# Rampion 2 Wind Farm

### Evidence Plan (Part 9 of 11)

Document Reference: 7.21

Figure 4 – SEL<sub>ss</sub> noise modelling contours for piling at the NW location, monopile, max energy

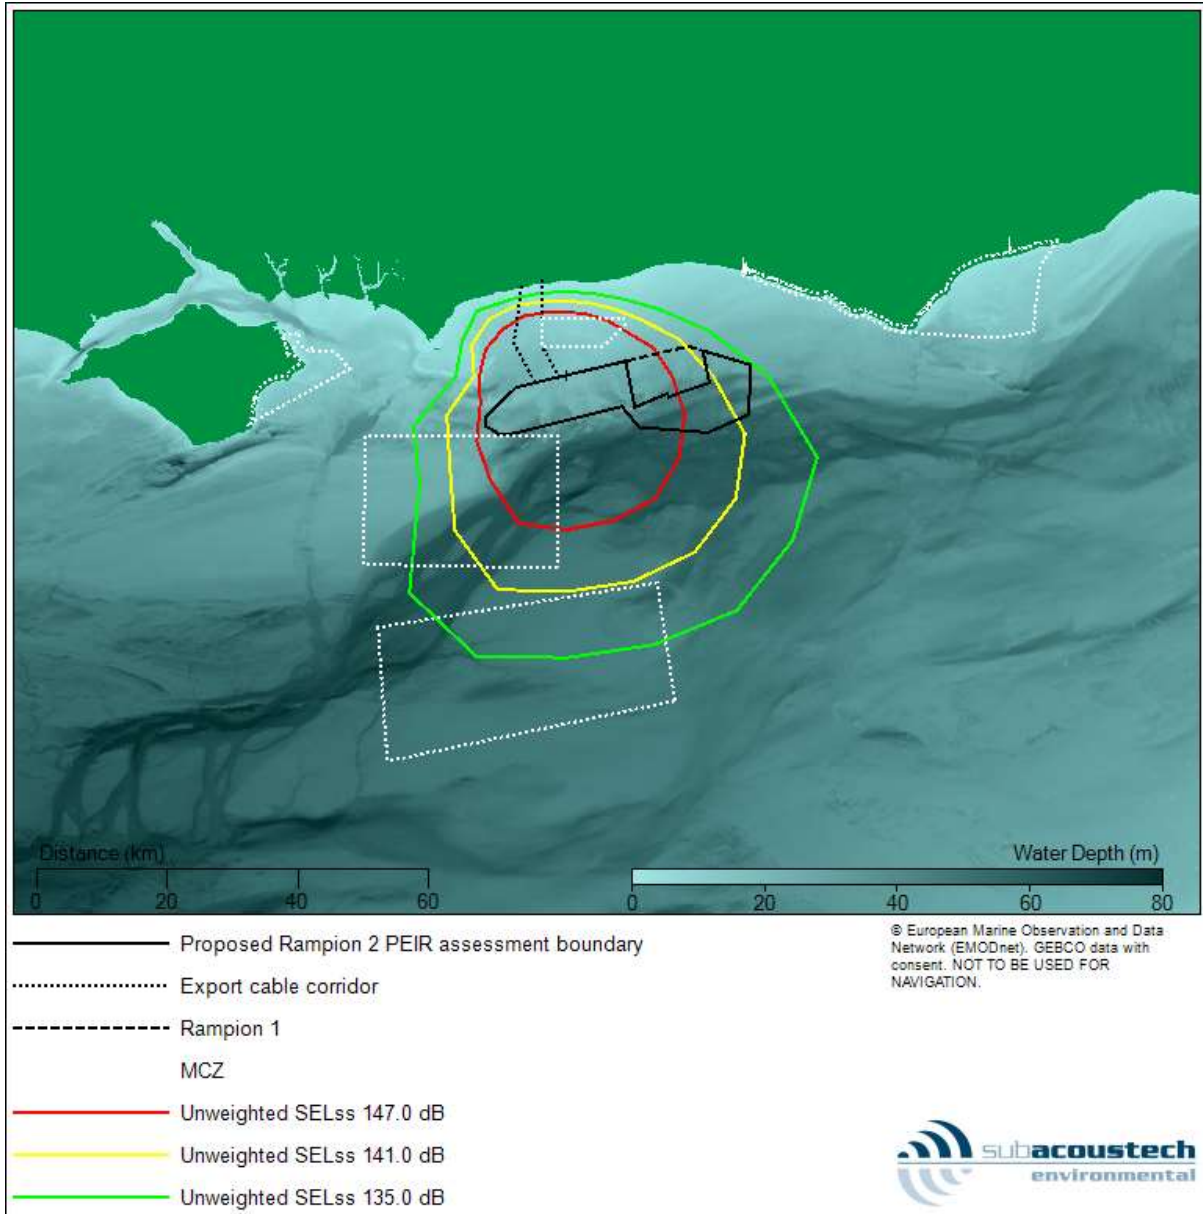
TN1 – figure 4 and figure 8 - in relation to Beachy Head West MCZ a clear overlap is seen with this site in the unmitigated situation shown in figure 4 (TTS) and figure 8 (potential disturbance). Therefore, in the absence of reliable mitigation there is the potential for underwater noise to have impacts on seahorses within this MCZ.

Figure 6 - SEL<sub>ss</sub> noise modelling contours for piling at the S location, pin pile, max energy

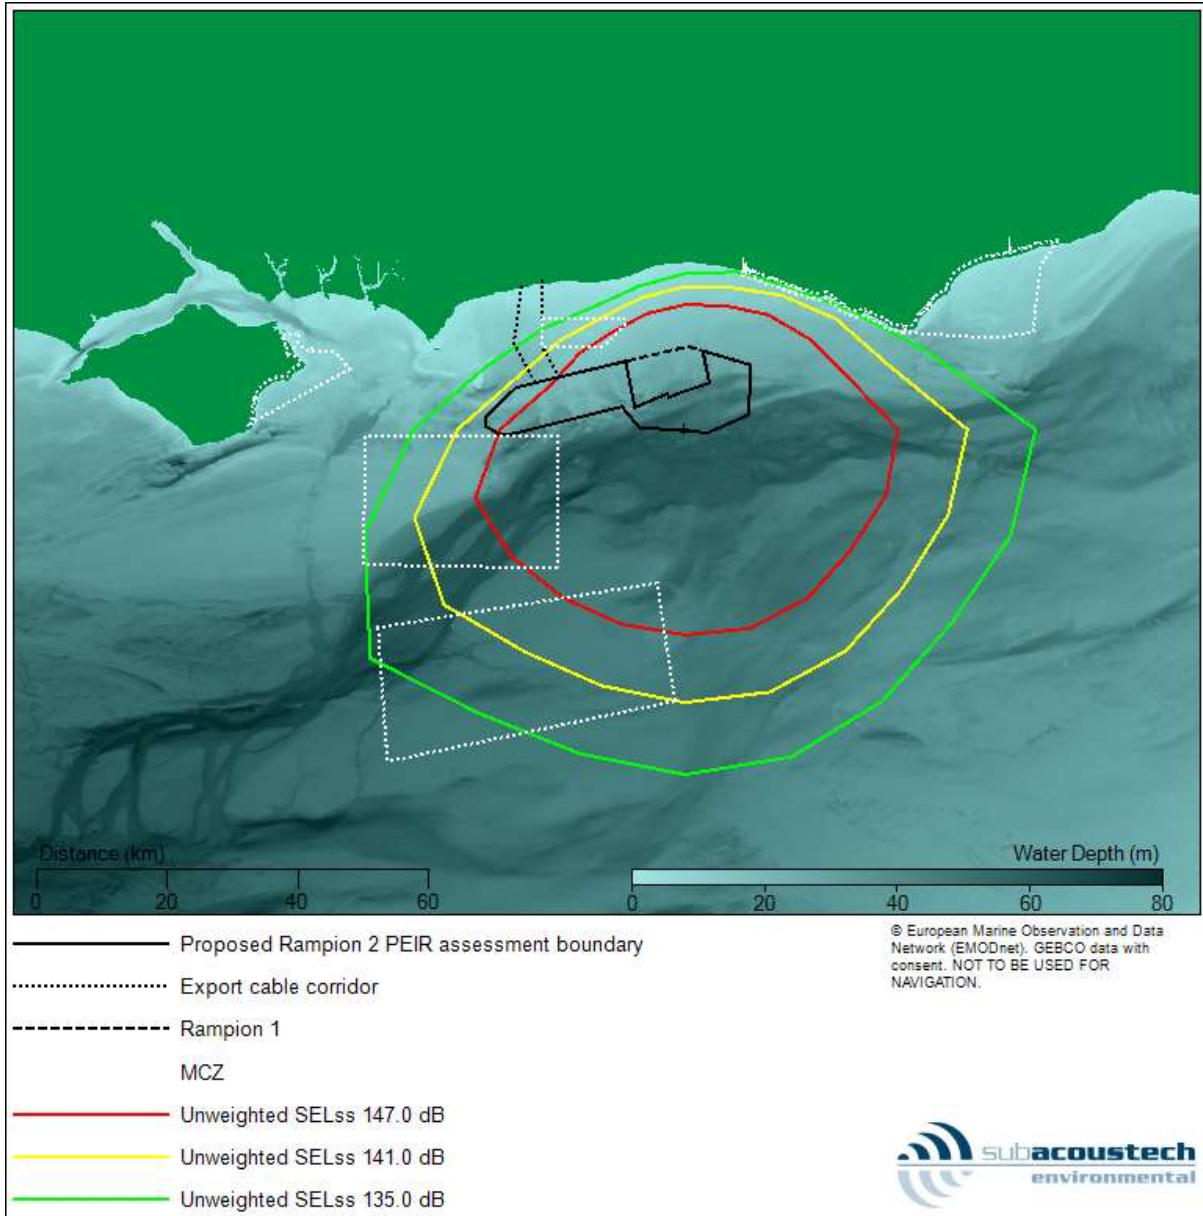
Hounds is designated for short-snouted seahorses and is in a location that has the potential to be impacted by underwater noise, so this should be shown. It is currently hard to distinguish if the unmitigated scenario in figure 6 and 10 overlaps with the site. Looking at these figures we would question whether there is a modelling location in the northeast of the site that may have more overlap with this site.

Figure 12 Contour boundaries, utilising 147 dB SELss (unweighted) model outputs with zero overlap target to the boundary of Kingmere and Beachy Head West MCZ, for worst case monopiles with various mitigations.

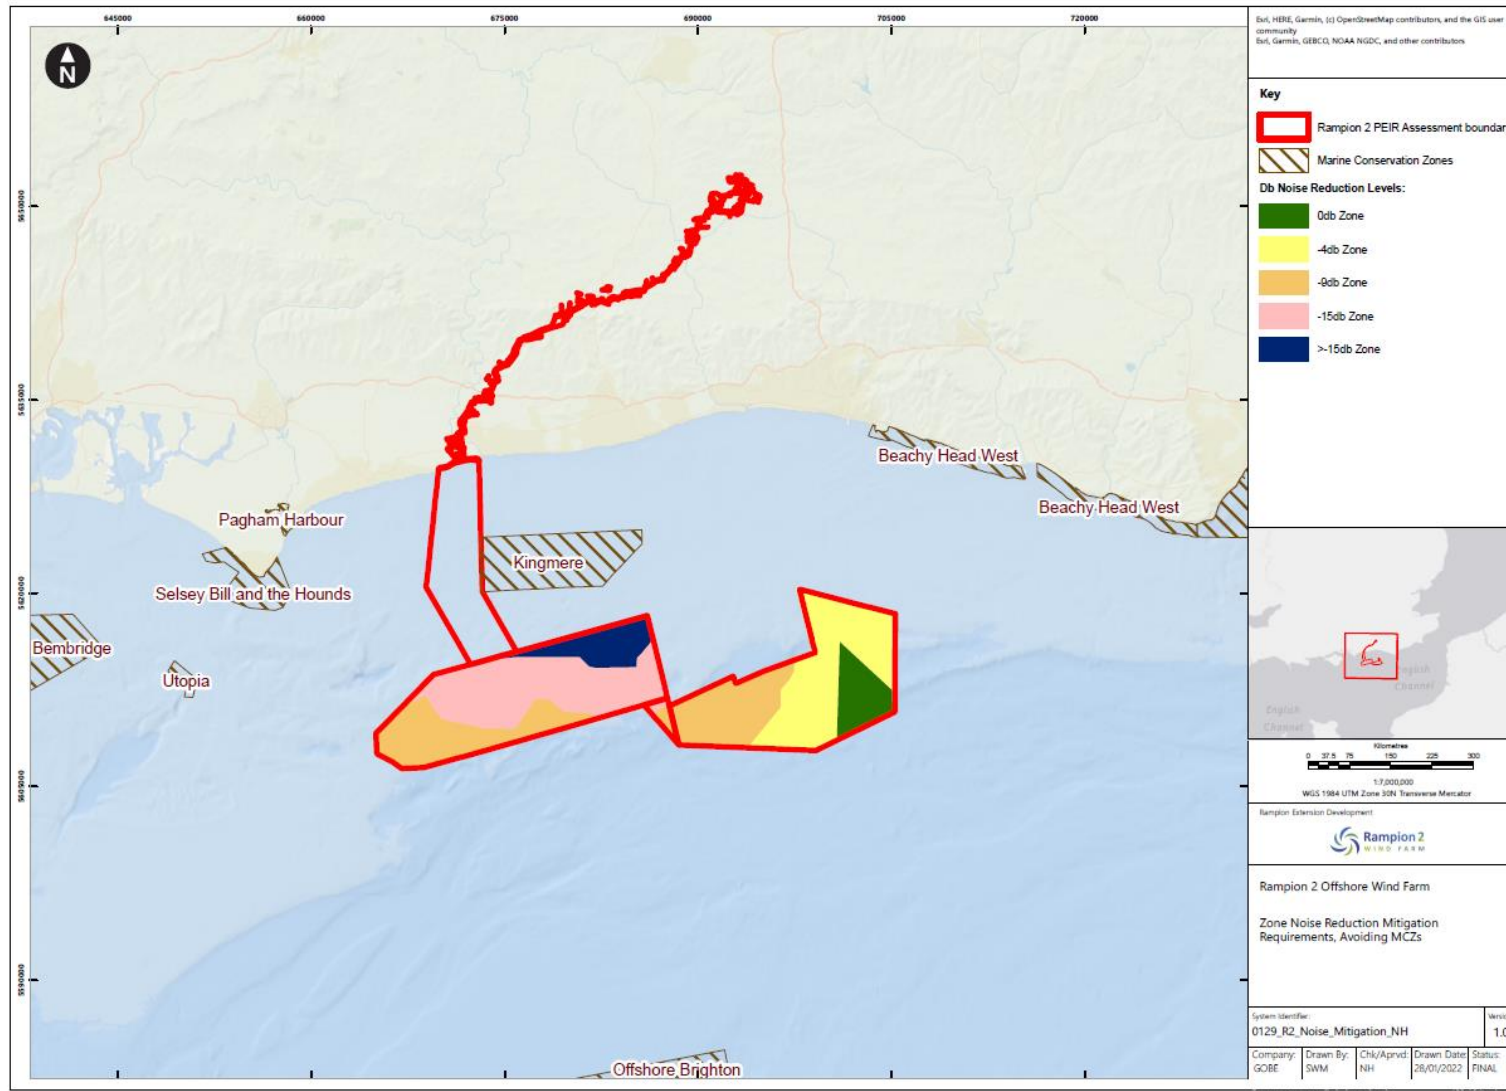
TN1 - figure 12 - The proposed zoning approach is reliant on modelling and a defined noise threshold. Both of these aspects involve significant uncertainties. A very small change to any aspect of the project could alter the level of noise attenuation required to achieve the numbers stated within the MCZ. Where there is so much uncertainty we would advise that the maximum level of noise attenuation that can be achieved should be proposed over the whole development site, rather than aiming for the minimum required.
